23 September 2022

NIGHT RACING AT ROYAL RANDWICK RACECOURSE -SSD-8706: RESPONSE TO REQUEST FOR ADDITIONAL INFORMATION, MARCH – MAY 2022

Figure 1 OLS Analysis Plan

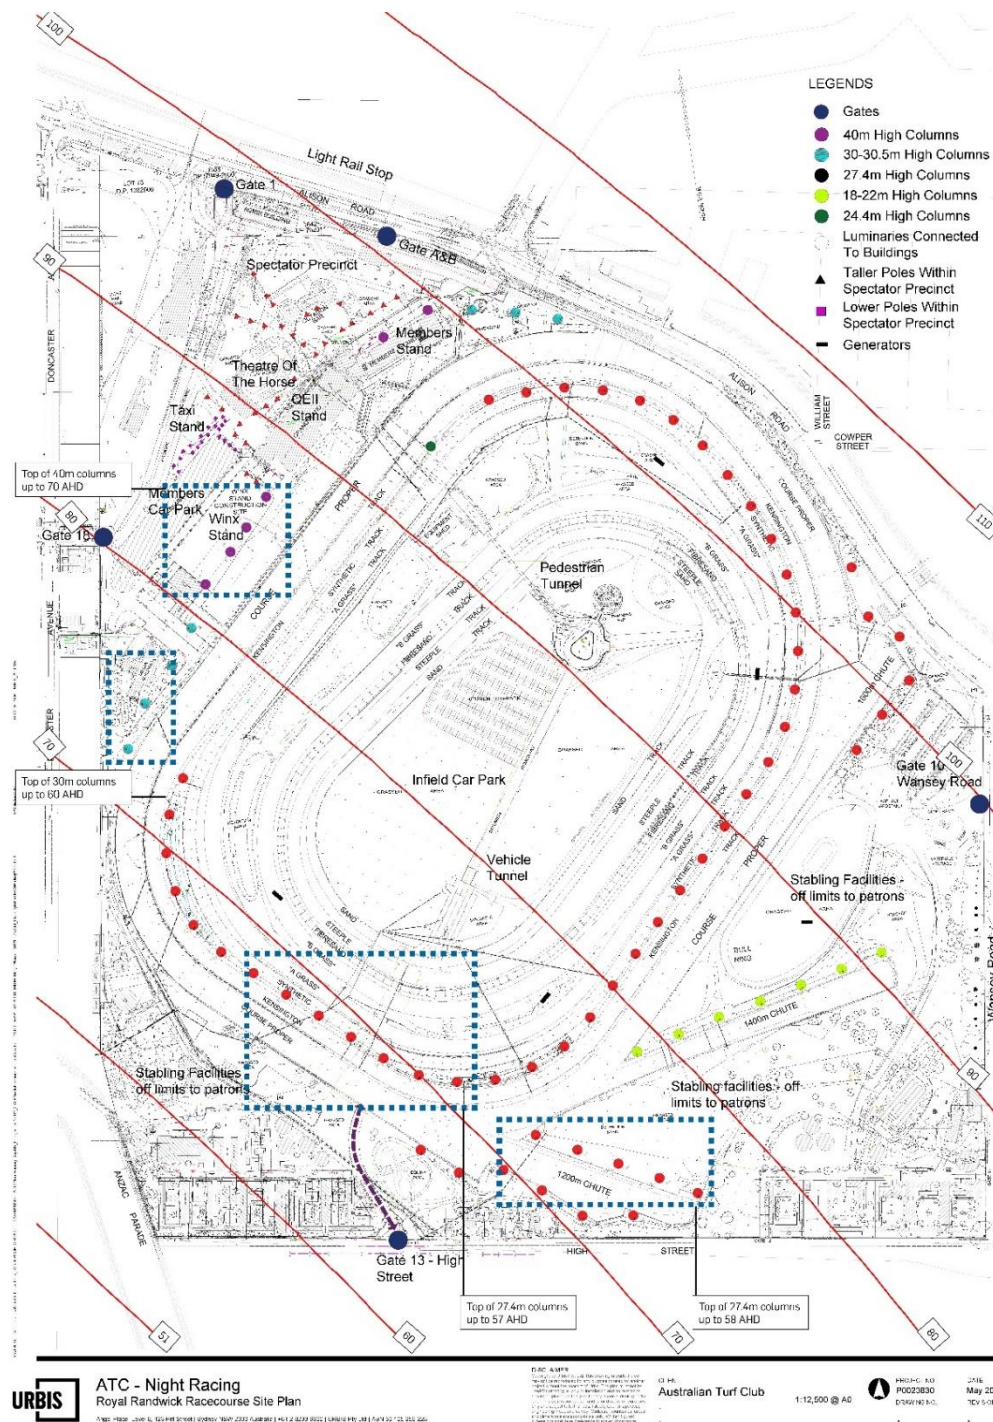
DPE requested the assessment of Clause 6.8 Airspace Operations of the Randwick Local Environmental Plan 2012, and confirm:

- *The height of the tallest lighting columns in AHD*
- *Whether lighting columns will penetrate the obstacle limitation surface (OLS) for Sydney (Kingsford Smith) Airport.*

Urbis has undertaken an analysis of the lighting columns in relation to the Sydney Airport OLS by overlaying the OLS contours over the Site Plan and extrapolating the AHD levels for the top of the lighting columns based on the ground levels and known height of the proposed lighting columns. The OLS Analysis Plan is shown in Figure 1 on the following page and provided in **Attachment D**. The OLS Analysis Plan shows that:

- The tallest lighting column located behind the Members Stand has a height of up to 70 AHD. These poles are located between the OLS height contours of 80 to 90 AHD and therefore are more than 10 metres below the OLS height plane.
- The height of the southern-most lighting columns proposed on site (nearest to Sydney Airport) are located just below the OLS height contours of 70 AHD. At this location, the tallest lighting columns have a height of up to 58 AHD and therefore are approximately 7 – 10 metres below the OLS height plane.

Based on the assessment, all proposed lighting columns are significantly below the OLS height plane and pose no risk to the operation of Sydney Airport. The following provides an assessment of the project in relation to Clause 6.8 Airspace operations under Randwick LEP 2012.
